CISPR/D/428/CC

COMPILATION OF COMMENTS ON COMMITTEE DRAFT

Project number: CISPR 12 Ed. 7.0	Reference number of the CD CISPR/D/427/CD
IEC/TC or SC CISPR/D	Date of circulation 2016-05-06
Title of the TC or SC: Electromagnetic disturbances related to electric/electronic equipment on vehicles and internal combustion engine powered devices

Title of the committee draft: Vehicles, boats and internal combustion engines - Radio disturbance characteristics - Limits and methods of measurement for the protection of off-board receivers
The above-mentioned document was distributed to National Committees with a request that comments be submitted
Report of comments See printout attached
Comments received – see annex ¹
DECISION OF THE CHAIRMAN (in cooperation with the secretariat) a <input type="checkbox"/> A revised committee draft will be distributed as a committee draft for vote (CDV) by (date) b <input checked="" type="checkbox"/> A revised committee draft will be distributed for comment by (date) 2016-12 c <input type="checkbox"/> The committee draft and comments will be discussed at the next meeting (date) NOTE In the case of a proposal <i>a</i> or <i>b</i> made by the chairman, P-members

Figure 8 – Antenna position when length of the vehicle/boat/device is smaller than the 3 dB beamwidth of the antenna N (number of antenna positions) = 1 and X (maximum gain reduction corresponding to the 2β antenna beamwidth angle) ≥ 3 dB, – Horizontal polarisation shown

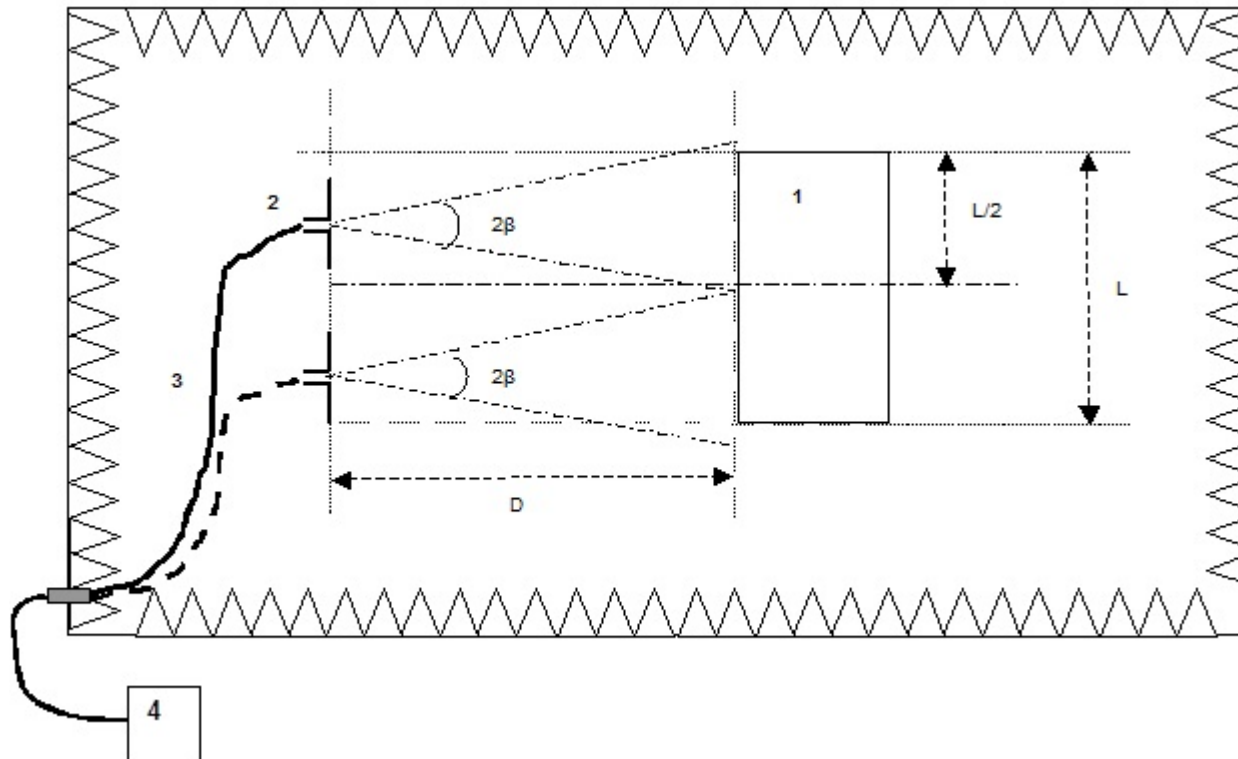
ANNEX FR-10

— if the length of the vehicle/boat/device is smaller than the 3 dB beamwidth of the antenna, only one antenna position is necessary. The antenna shall be aligned with the middle of the total vehicle/boat/device length (see Figure 8)

— if the length of the vehicle/boat/device is greater than the 3 dB beamwidth of the antenna, multiple antenna positions are necessary in order to cover the total length of the vehicle/boat/device (see Figure 9). The number of antenna positions shall allow to meet the following condition:

Figure A.1 — Determination of the maximum antenna angle

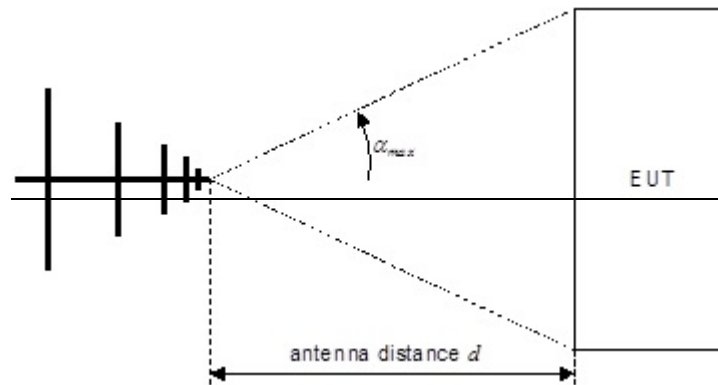
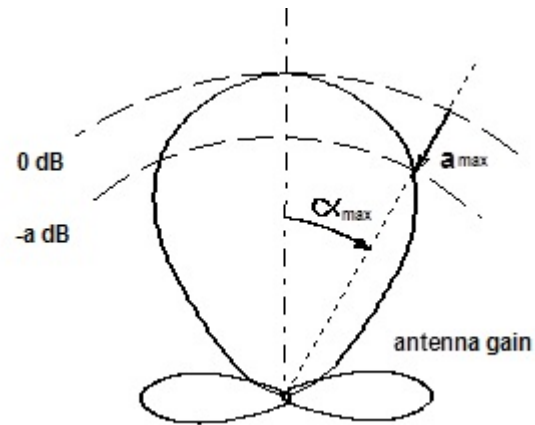
Read from the antenna directional pattern the gain reduction a_{\max} X dB at the maximum antenna angle α_{\max} β (see Figure A.2 A.1).

In Figure A.1 replace α_{max} by β and $-a$ dB by $-X$ dB

Figure A.1 – Calculation of the resulting gain reduction a X

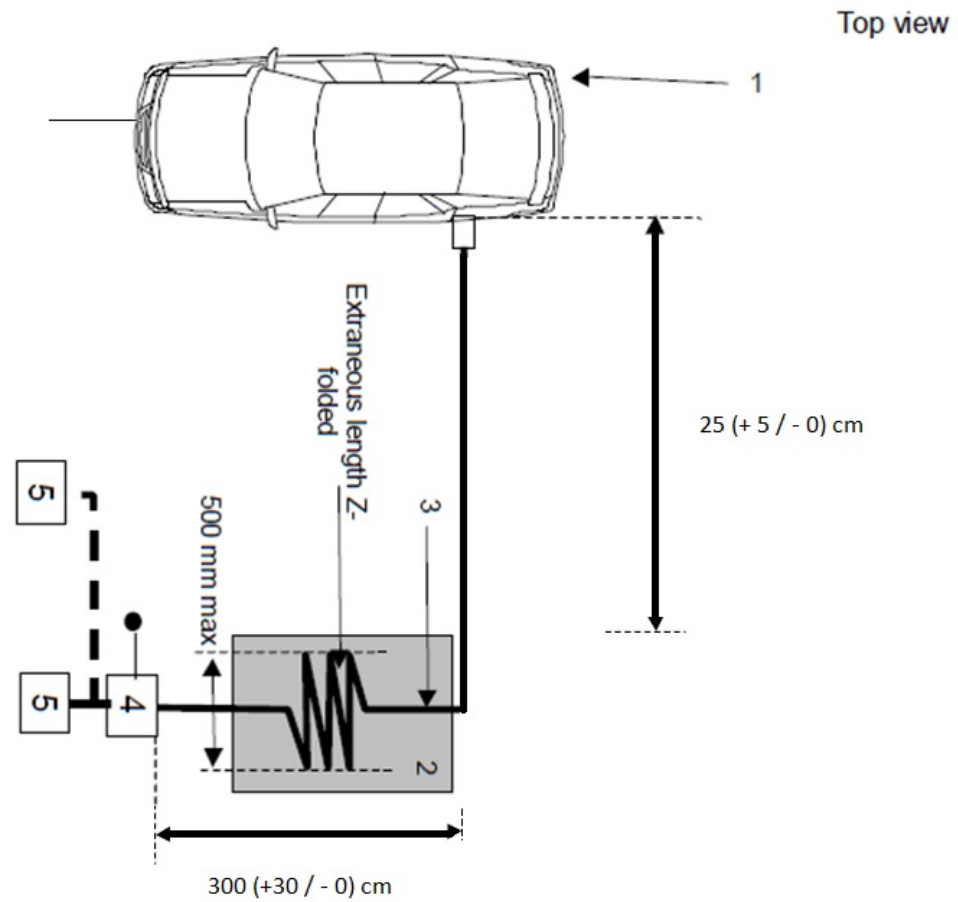
Calculate the alternative emission limit by subtracting from the original limit line the absolute value of the maximum gain reduction a_{max} :

Calculate the alternative emission limit by subtracting from the original limit line the absolute value of :

$$COR_{dB} = 3 - X_{dB}$$

Where X_{dB} is the maximum gain reduction

New proposal for lower half of Figure 10 - Example of test setup for vehicle with plug located on vehicle side

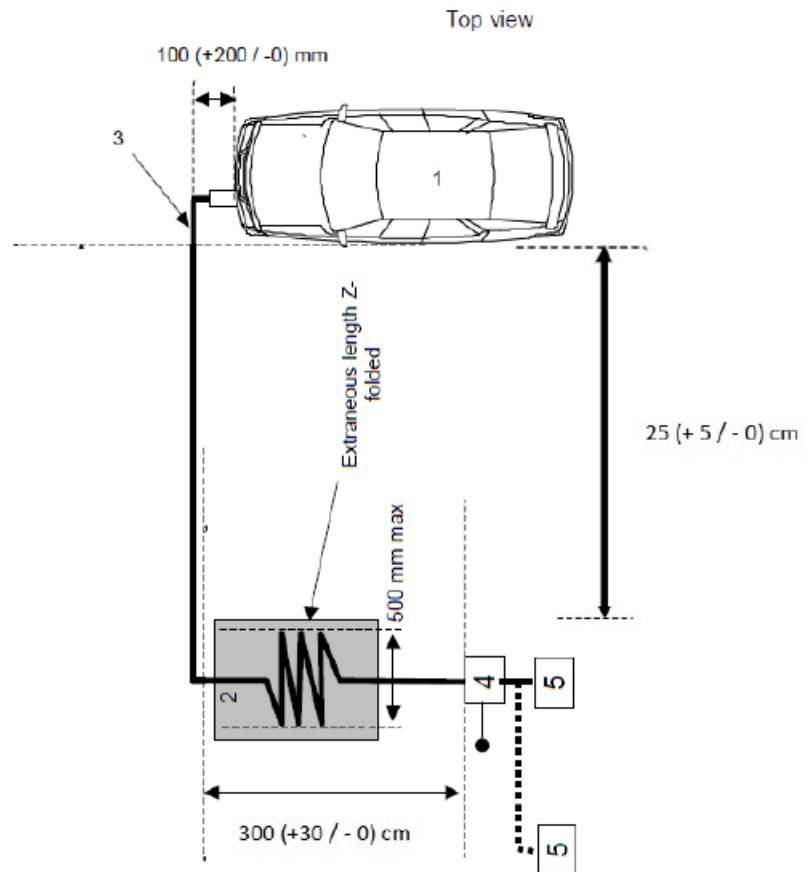
Modified version of the lower half of Figure 10:
